To: Susan Grant, Acting City Manager
From: Alan Dodd, Director – Public Works
Date: June 3, 2024
Re: Change Order # 4 for Project #12765 PO 6189

Job Description: Project #12765, Prospect Lake Clean Water Center
Contractor: Prospect Lake Water, L.P.
Amount: Total amount of Change Order # 4 \$3,275,339 plus 0 additional days
Funding: 10-494-7999-536-60-6599-P12765

Subject: Prospect Lake Clean Water Center Design Build Contract
Response to Scope Change Order Proposal Request – City Obligations: 54 –Inch Feedstock
Watermain

PROJECT # 12765 FEEDSTOCK WATER MAIN TO PROSPECT WATER TREATMENT PLANT FORT LAUDERDALE, FLORIDA

48"x54" DOUBLE DOOR ALUMINUM HATCH
 MODEL APD300
 N.T.S. (REFER TO U.S.A. FABRICATION, INC.)

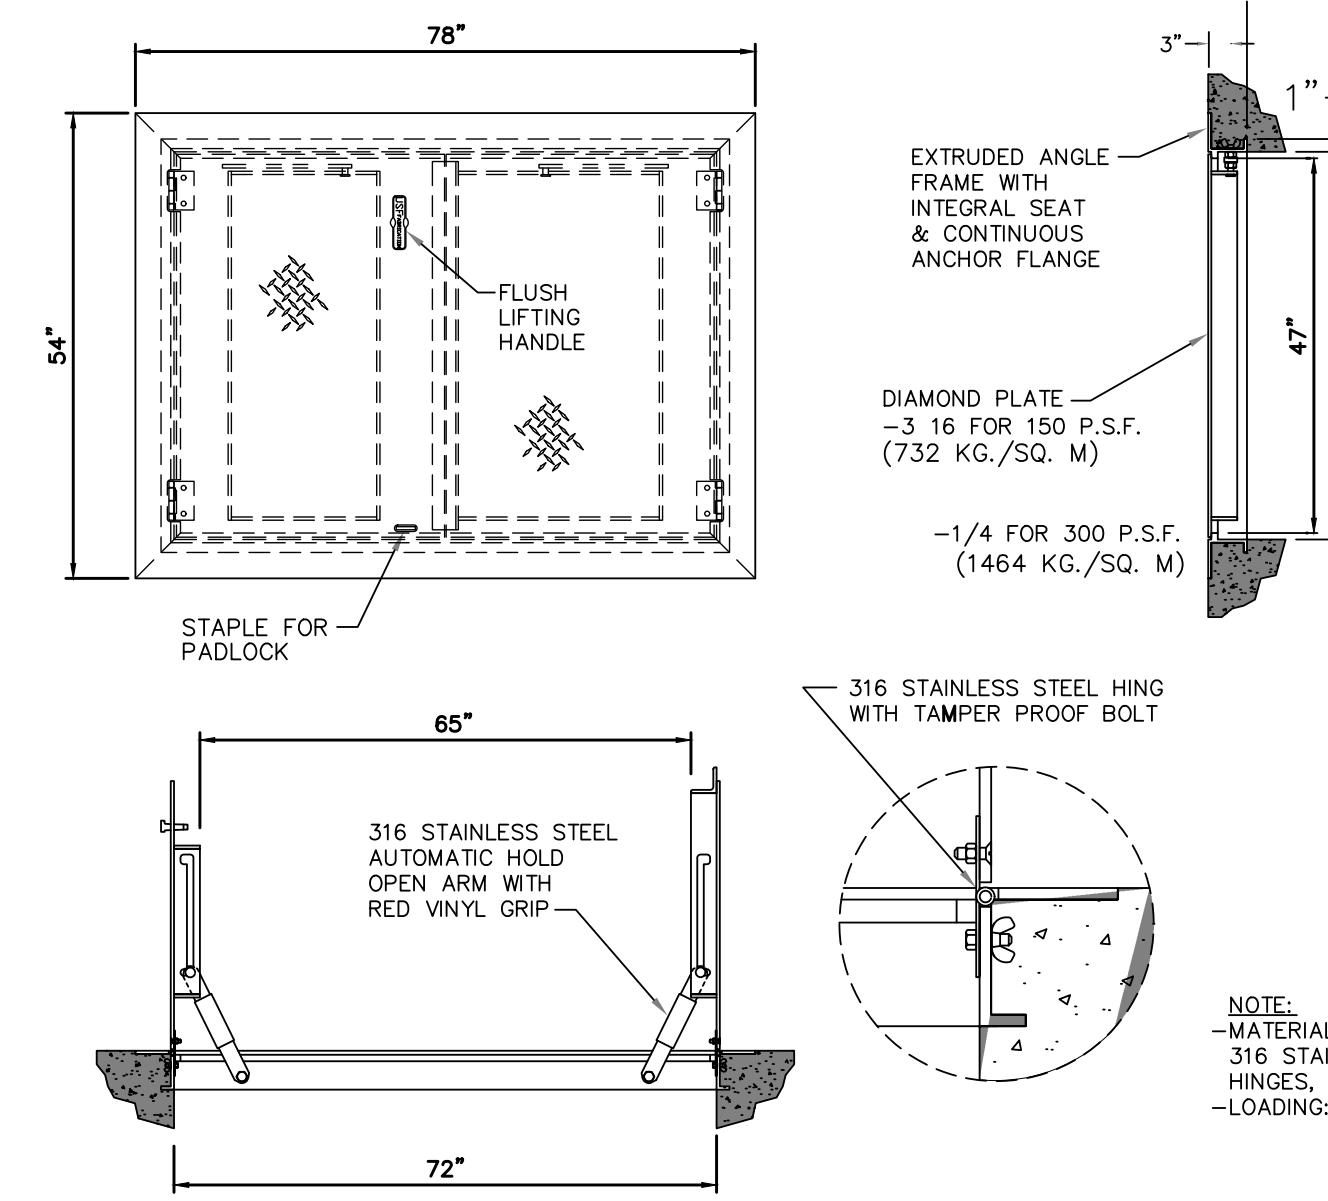
18. **Drawing D-3:** Drawing no. D-3 in the FWM Design Plan does not apply as there shall be no meter.
19. **Hazardous Materials:** General Note no. 44 in the FWM Design shall not apply. For the avoidance of doubt, Kiewit's rights and obligations with respect to hazardous materials will be as set out in the Comprehensive Agreement and the DB Contract.
